SUBJECT: Montgomery County – C.J. Corridor; PID # 101711
Findlay St, DOT # 527819M

RE: Grade Crossing Warning Device Improvements
Montgomery County – C.J. Corridor; PID # 101711
Findlay St, DOT # 527819M

The plan and estimate dated May 5, 2017, for the referenced project has been reviewed and is acceptable. Norfolk Southern Railway Company may proceed with the construction of the proposed grade crossing warning system in accordance with the abbreviated plan. This authorization is made with the stipulation and understanding that the approved estimate may contain entries for items or activities that may be cited and found to be ineligible for federal participation during the project audit. Reimbursement of eligible actual cost is limited to \$392,179.00. Additional costs must be approved in writing by the Ohio Rail Development Commission (ORDC) prior to being incurred. Emergency verbal authorizations by ORDC may be permitted and will be confirmed by ORDC in writing within ten (10) business days of the verbal approval.

DESIGNED BY: JWB 11-04-16	 NORFOLK SOUTHERN	
DRAWN BY: IRE 11-04-16	OFFICE OF ASS'T. VICE PRESIDENT COMM. & SIGNAL, ATLANTA, GA.	M.P.: CJ-205.92
CHECKED BY: DBS 11-05-16	DAYTON, OH CFLGS AT FINDLAY ST.	
IN SERVICE:	DAYTON DISTRICT	FILE No. R-
- -	CADD or DWG. No. 82112059.01	SHEET No. 1 of 25

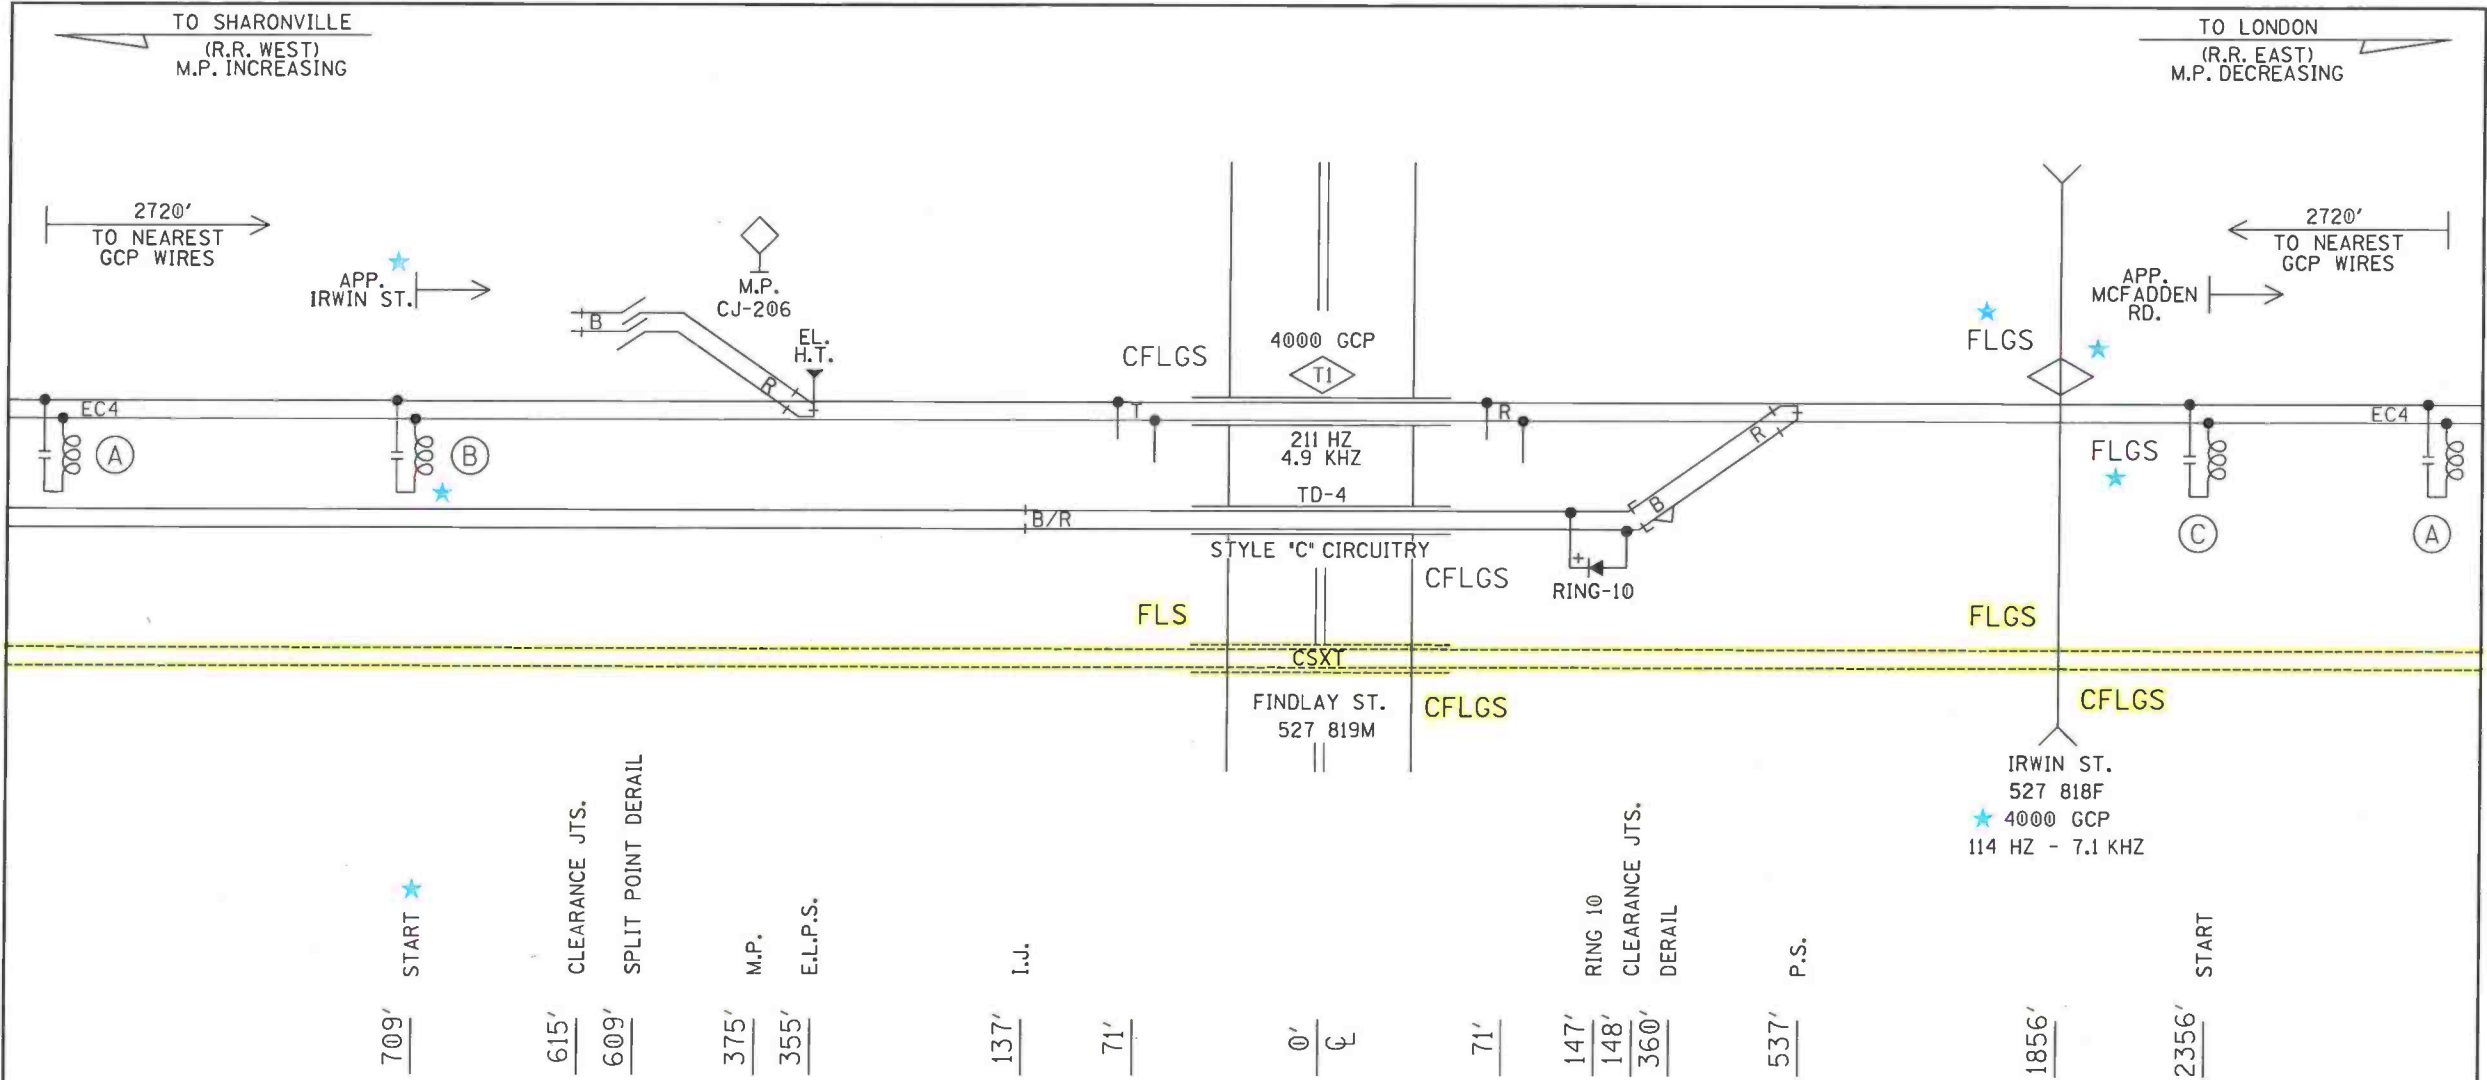
9. All warning device foundations must be placed 4' 3" from face of curbs.
10. Norfolk Southern Railway Company to send an approved plan with PE stamp prior to final billing of completed project.
